## Details Matter

### The Glitch:

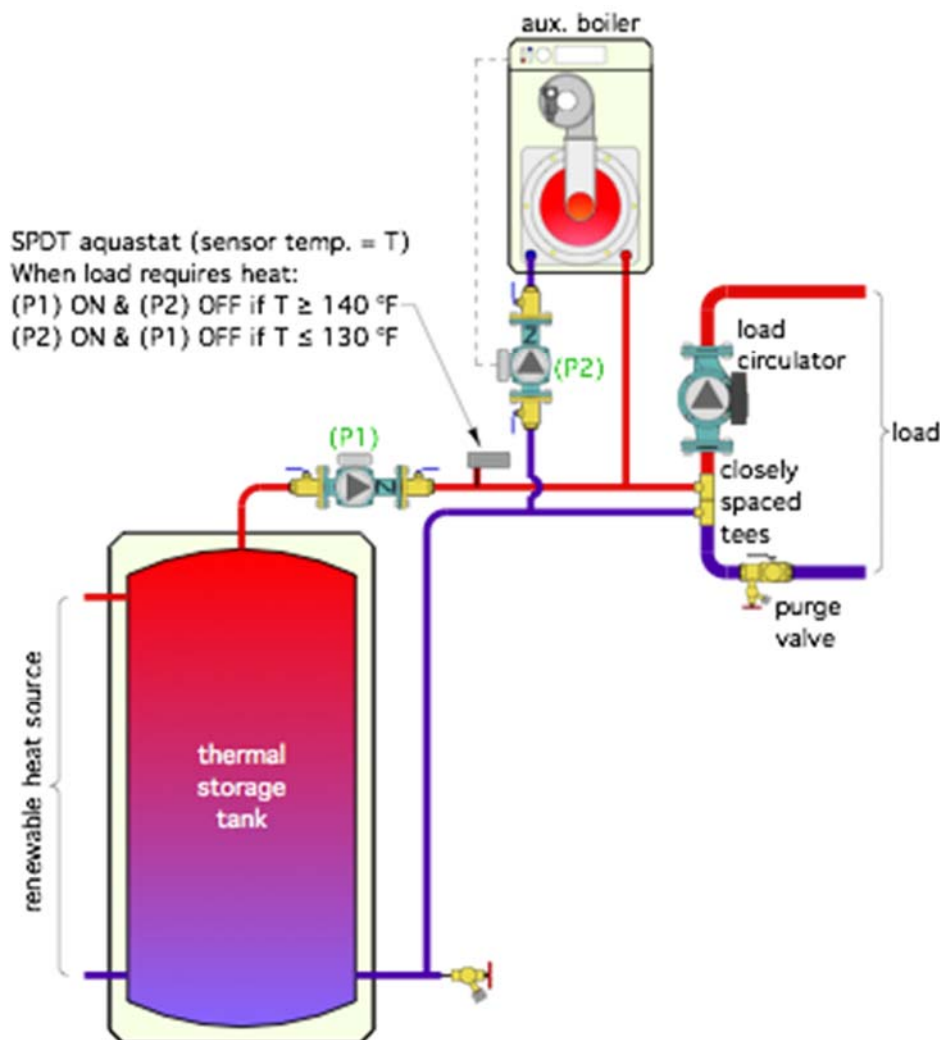
When a heating load is present, and the load circulator turns on, the tank is to supply the load if the water at the aquastat is at or above 140°. In this case circulator (P1) needs to run and circulator (P2) and the auxiliary boiler should be off. If the temperature at the aquastat is less than or equal to 130°, the auxiliary boiler should be on, circulator (P1) should be off, and circulator (P2) should be on.

During a follow up site visit the installer notices that the temperature at the top of the tank is 145° F, (P1) is off, and the auxiliary boiler and circulator (P2) are supplying heat to the load. It's not supposed to work like that.

Circulators (P1) and (P2) both have internal spring-loaded check valves. Assuming that the aquastat is operating correctly, and that essential details such as an expansion tank, PRV, etc. are all present and correctly installed (they're just not shown), why is the system behaving this way? Do you see any other details that should be changed?

In the glitch drawing the aquastat is located downstream of a circulator with an internal spring-loaded check valve. That valve prevents water in the tank from reaching the aquastat's sensor unless circulator (P1) is operating. The thermal storage tank could be filled with hot water, well above the required 140° temperature, but when the heating load occurs, the aquastat is "feeling" a temperature well below the 130°. The auxiliary boiler and circulator (P2) turn on to satisfy the load. The building remains comfortable, and the owner is unaware of the issue. It may not generate a call back, but it's not right, and any responsible heating pro should determine there's a problem and fix it.

A couple of other details that should be fixed:

1. The purge valve in the load circuit is installed backwards.
2. The load circulator should have at least 12 pipe diameters of straight pipe upstream of its inlet to suppress turbulence.

The control concept is fine, and the fix is simple: The aquastat needs to sense the water temperature at the top of the thermal storage tank (as shown in the fix drawing).
